From: McConnell, DAVE P <dave.p.mcconnell@lmco.com>
Sent: Thursday, August 10, 2017 6:23 PM
To: Grant Robinson
Cc: Thomas Jacobson
Subject: S-92 Aft float bottle forward bracket tapered shims

Case Number: C0067550
Customer: Thai Aviation Services Limited
Aircraft S/N: 920XXX
Aircraft Model: S-92A
ATA: 53
Part Number: 92201-05132-series
Case Subject: Request To Add Tapered Shims To Aft Float Bottle Supports

Reference attached JPEG image.

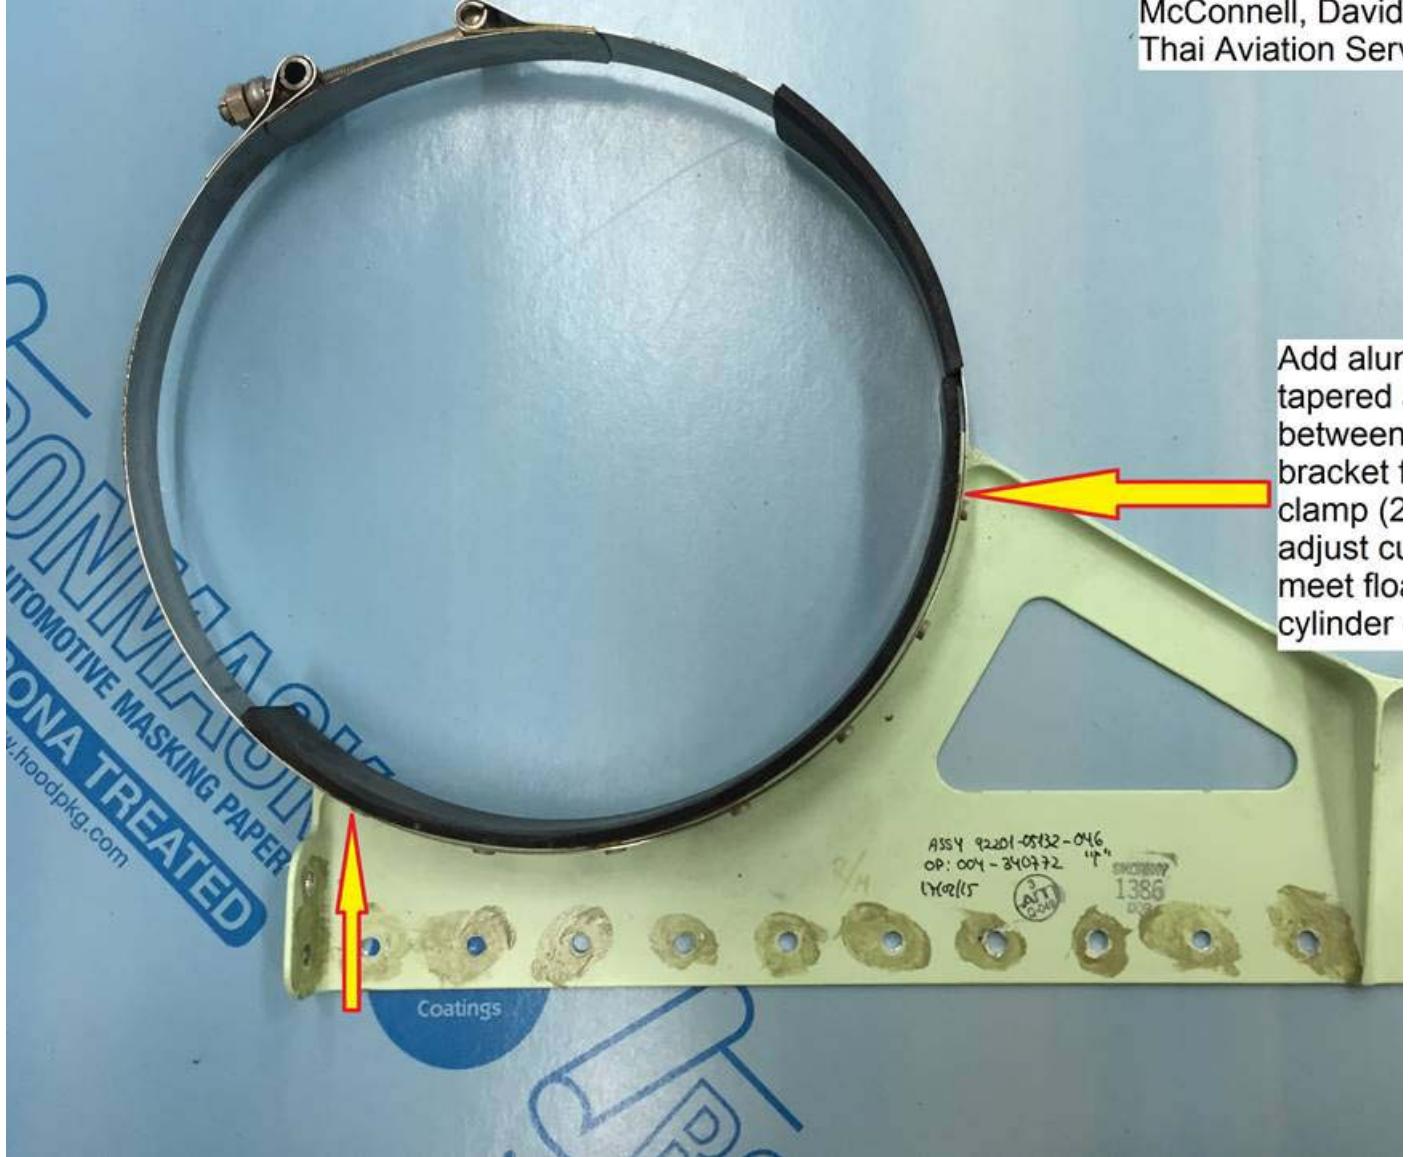
TAS maintainers removed P/N 92201-05132-045 / -046 aft float bottle forward supports for cracking during the ongoing 1500-hour inspection on A/C S/N 920279.

It was observed that neither support's flange correctly matched the curvature of the float bottle.

Their concern is that shimming may not always be done the same way by different maintainers, or may not be done at all.

TAS propose to permanently add two aluminum shims to each P/N 92201-05132-series float bottle support assembly.

The shims will be tapered as required to achieve a support flange radius that matches the float bottle cylinder, and will be sandwiched between the P/N 92202-05126-series bracket flange ends and the P/N MS21920-59 band clamp, picking up on at least two existing rivet holes. No new rivets will be required.

TAS request SA no objection for this proposed modification.

Sikorsky Structures has no objection to addition of tapered shims as these are permanently attached with existing rivets.
